SUBJECT: Letter of Clarification 4

RE: Request for Competitive Sealed Proposals for Construction Contract for Lynn Wyatt Square Project

Figure 1.

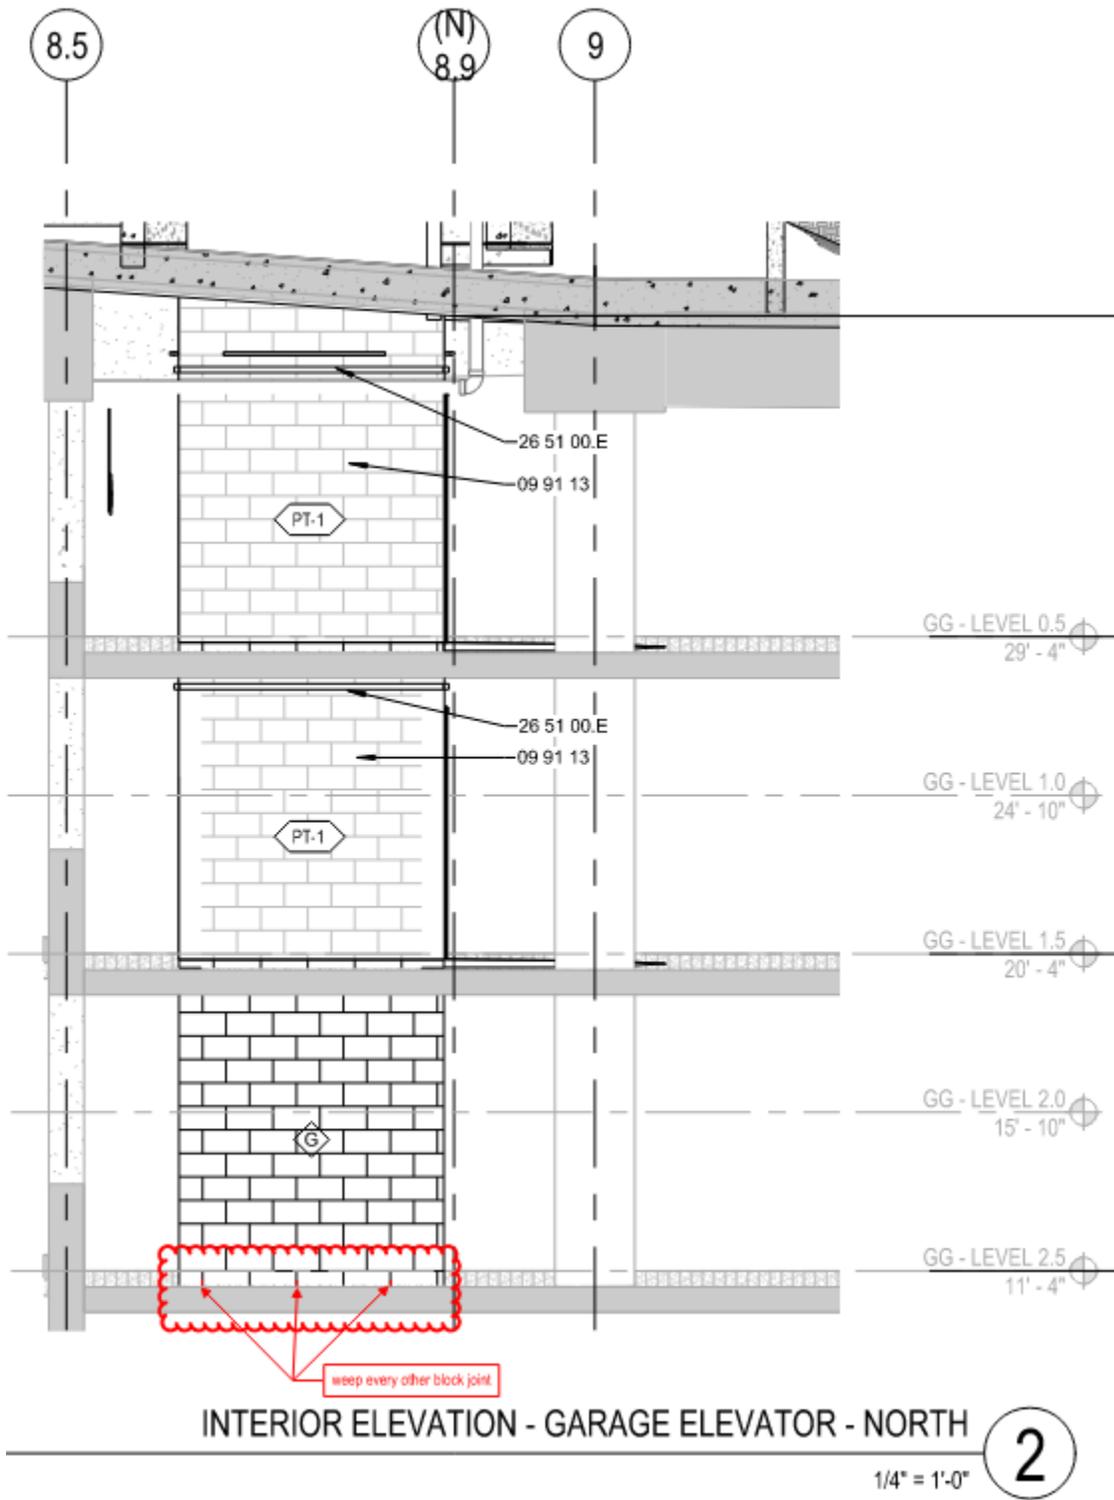
Question 13: a) Structural and Architectural Drawings do not show a sump pit in the Elevator shaft at Level B3 and there is no indication of any requirements on the Plumbing drawings. Please confirm a sump pit is not required.
b) Sheet A00.03 references Sheet A10.00 for Weeps in the CMU Walls for the Elevator Shaft on B3. There are no weeps indicated on Sheet A10.00. Please clarify and advise if these weeps are to be at grade on Level B3 or if they are at the Composite Deck Elevation per Sheet S2.50.
c) Please advise on the Elevation of the composite slab in the elevator shaft indicated on Sheet S2.50.
d) Detail 17/S2.50 references the Plan (S1.01) for the composite slab thickness and reinforcing. This information is not indicated, please advise.

Answer: a) The elevator pit slab is elevated above the existing garage floor slabs. A floor drain will be installed in the elevator pit slab, this floor drain's discharge will exit the shaft and route horizontally to the nearest sanitary riser.
b) See Attachment A, Figure 1 for clarification sketch of weep location
c) Slab elevation will be determined by final elevator pit depth requirement (G.C. to coordinate)
d) Elevator pit floor structural deck to be 2 1/2" normal weight concrete topping on 1 1/2" composite deck (4" total thickness) reinforced with WWR 6x6 - W2.9xW2.9 See updated drawings provided in Bid Addendum 1.
